ADDENDUM #2

Project Name:
Newton Correctional IPI Homes for Iowa Phase II - Fencing
DAS Project # 9239.04
RFB 923904-01
Addendum #2
Dated: June 16, 2026

SHEET TITLE:
SALLYPORT & PARKING
LAYOUT

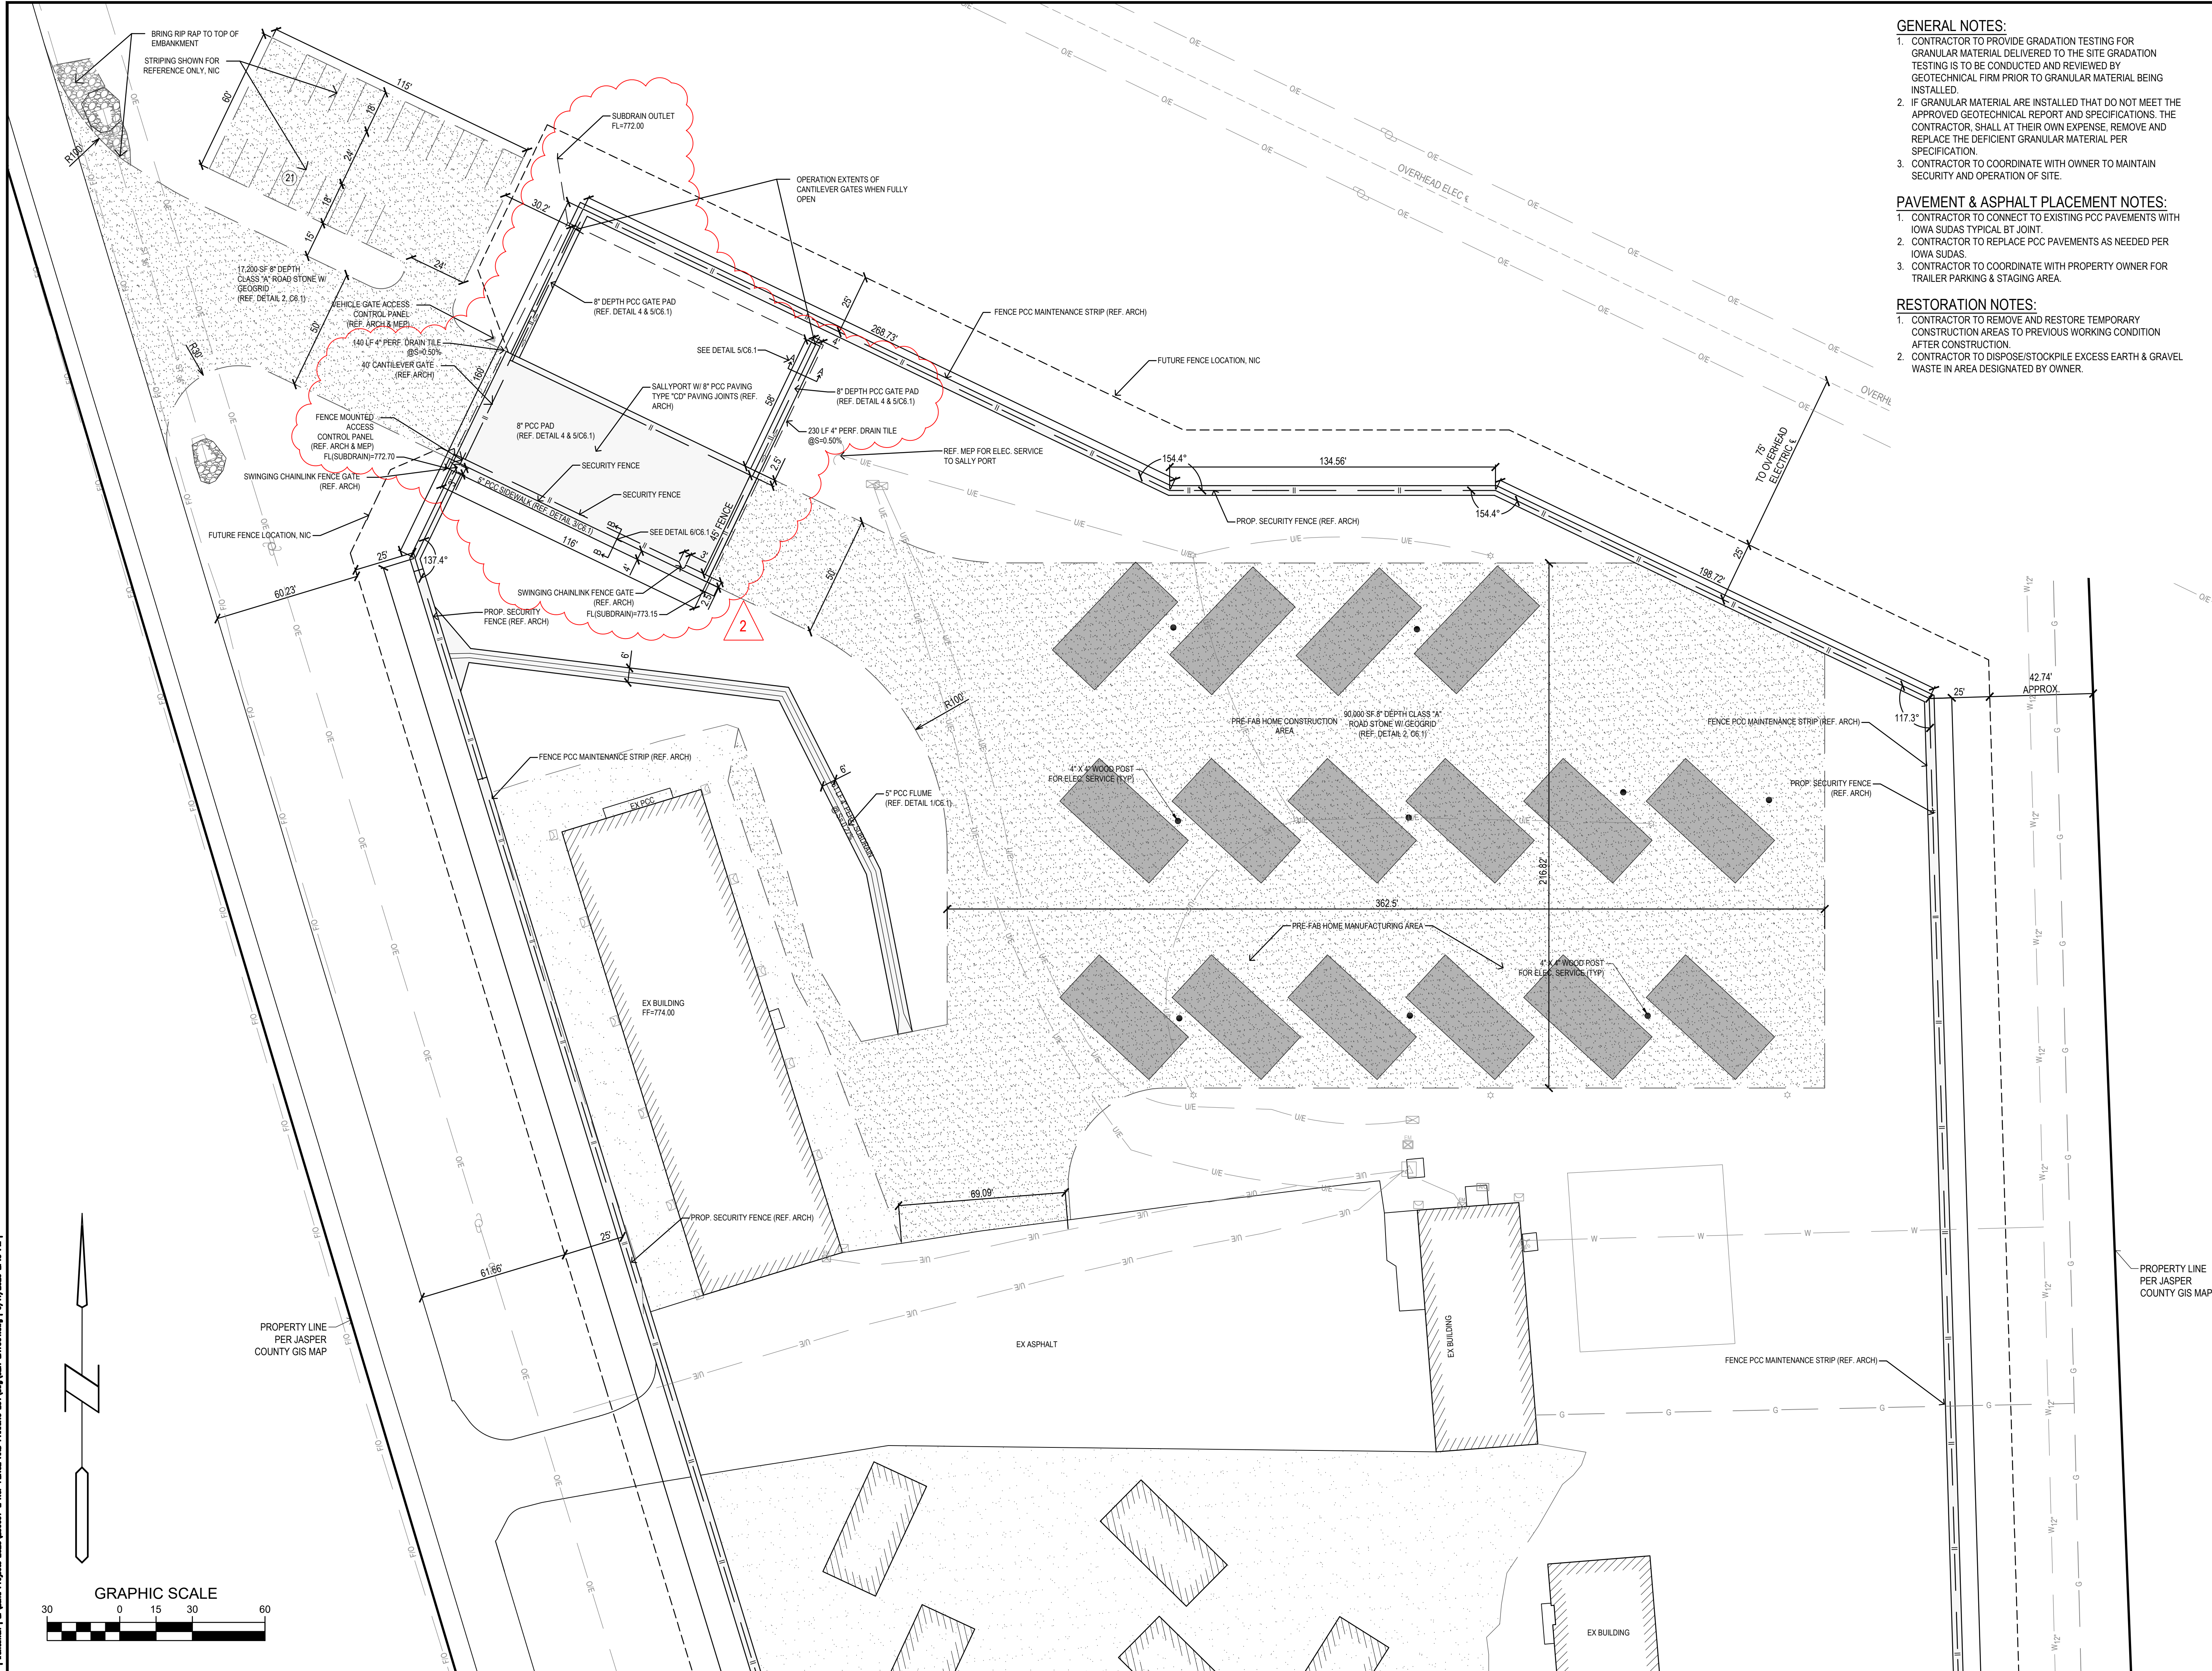
- Item No. 3 Added Subdrain and Callouts around North, East and West sides of Sallyport and Gate Slides
Item No. 4 Adjusted Callouts to reflect new and altered Details on Sheet C6.1

- Item No. 5 Added Callouts for 5" PCC Flume, Southeast Man Gate and Fence Maintenance Strip.

SALLYPORT & PARKING
GRADING PLAN

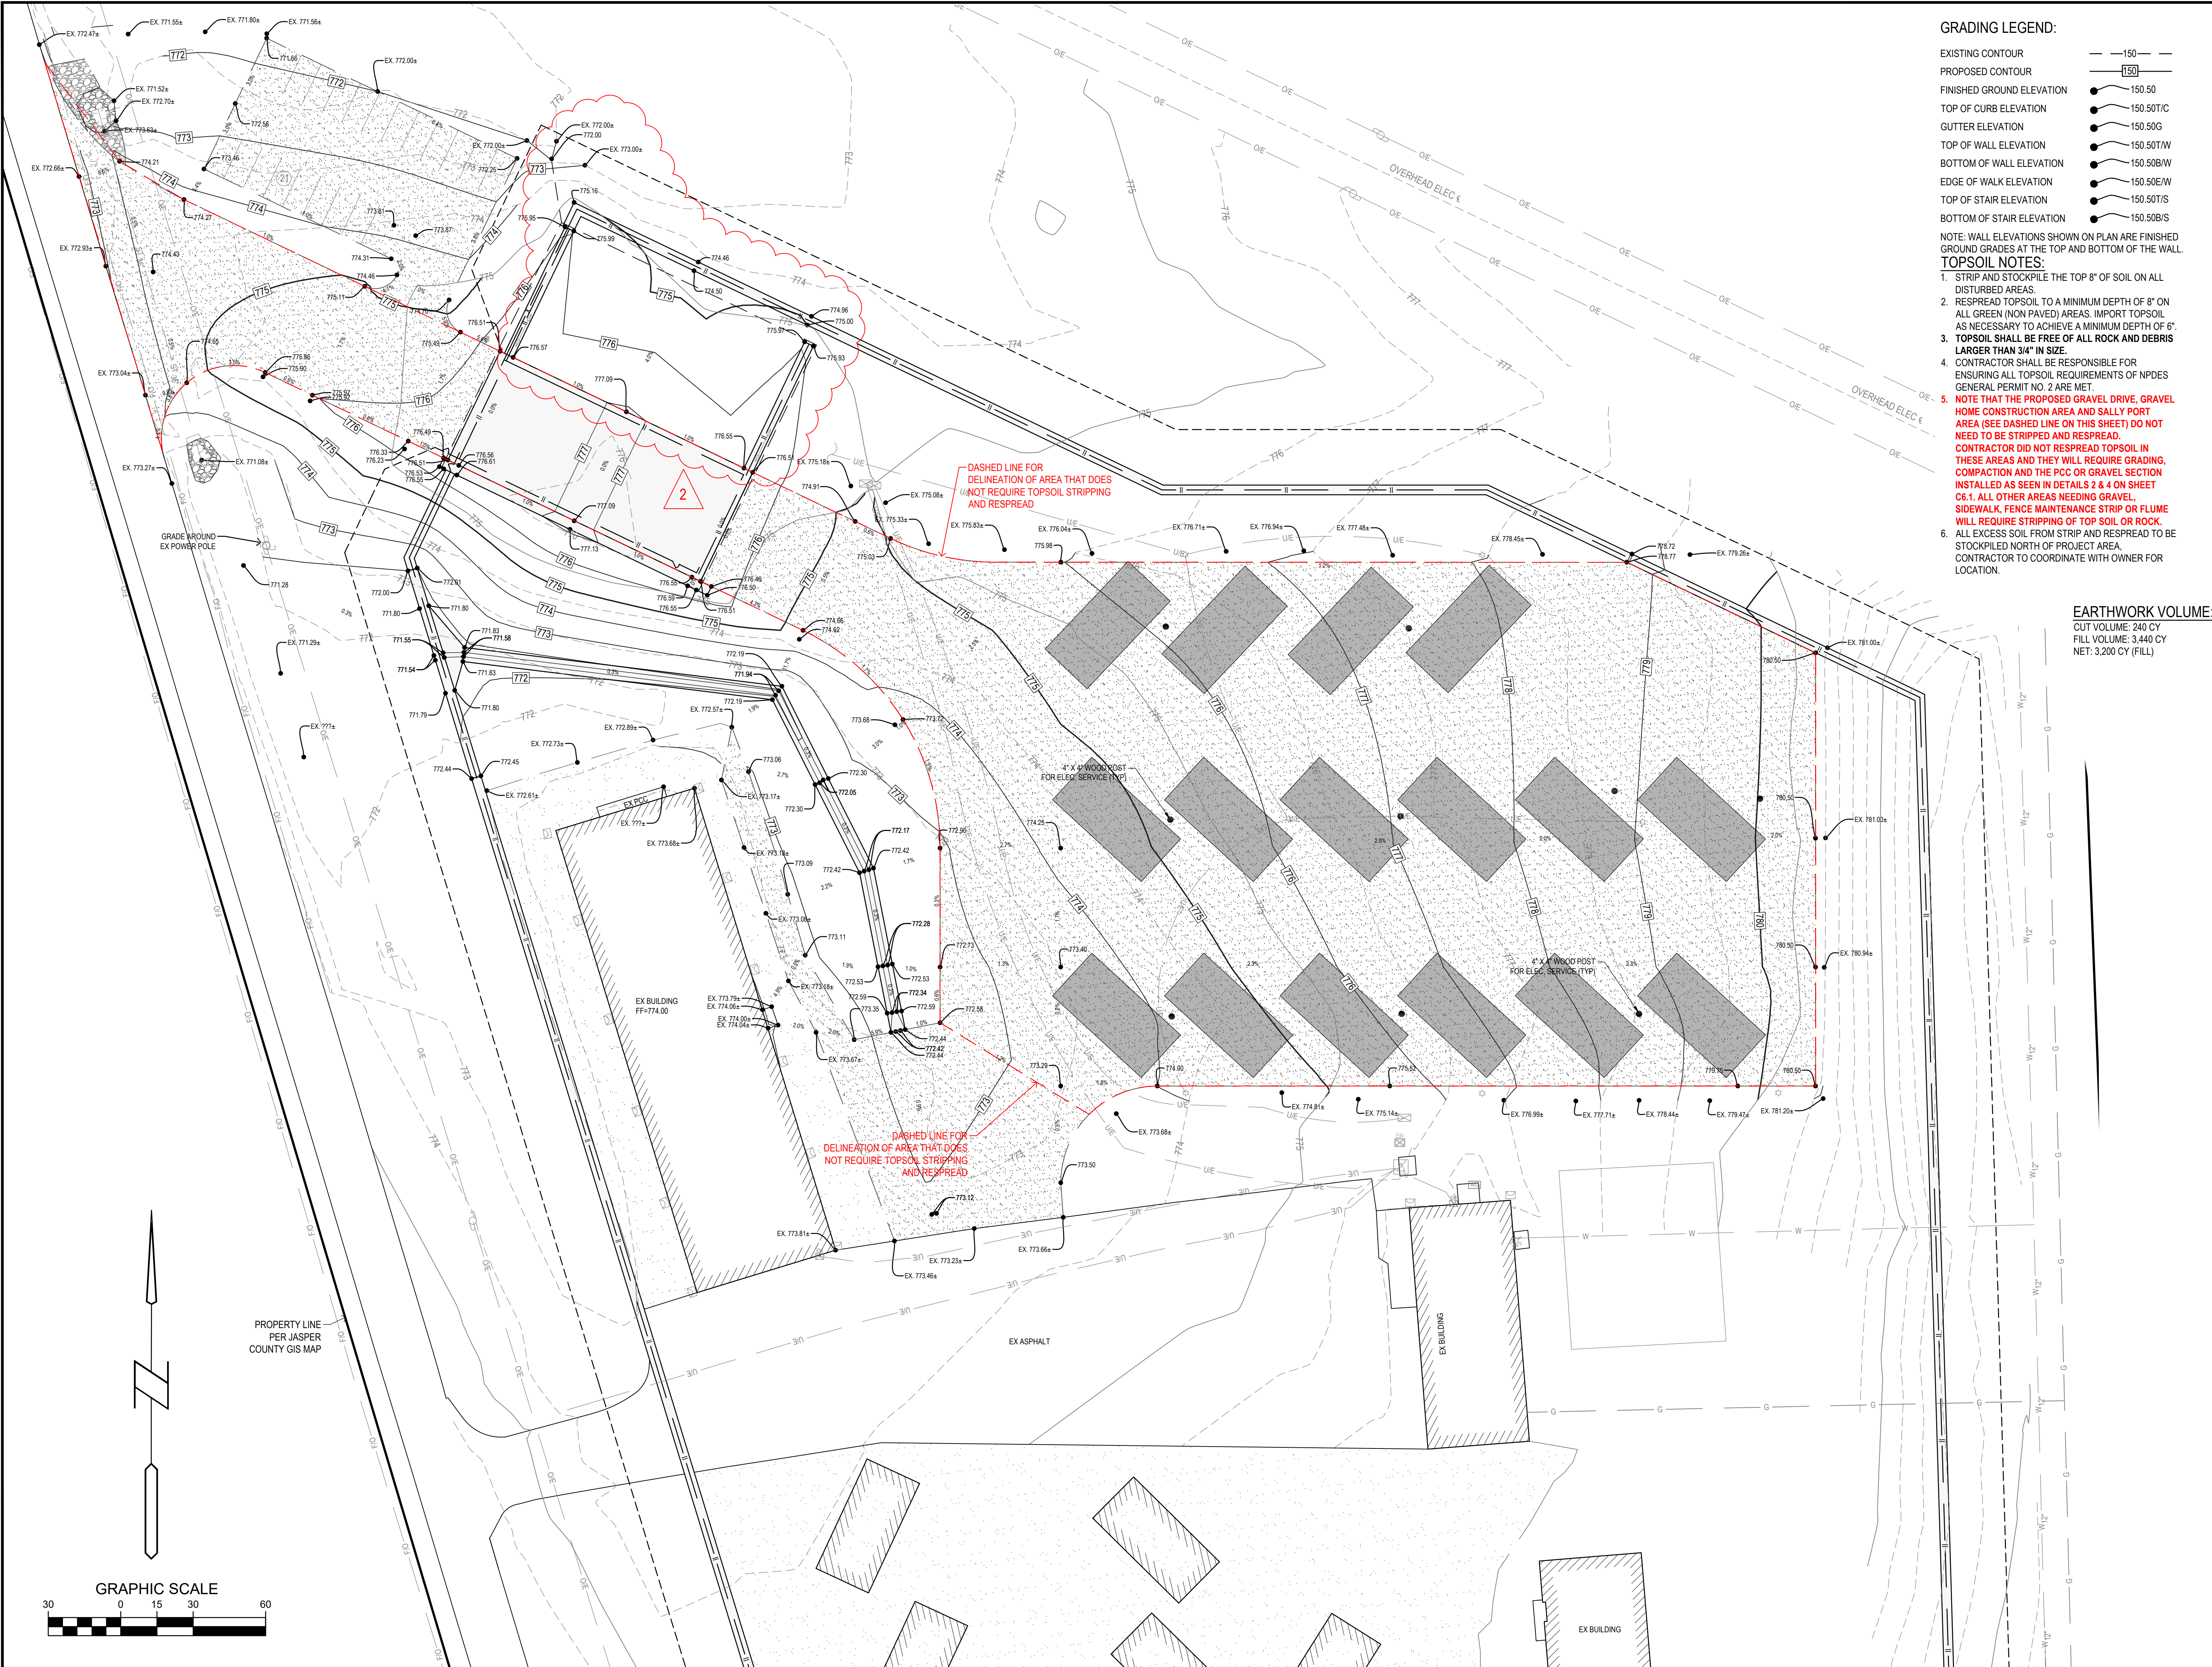
- Item No. 6 Minor Grade Adjustments for Sallyport drainage and added subdrain.
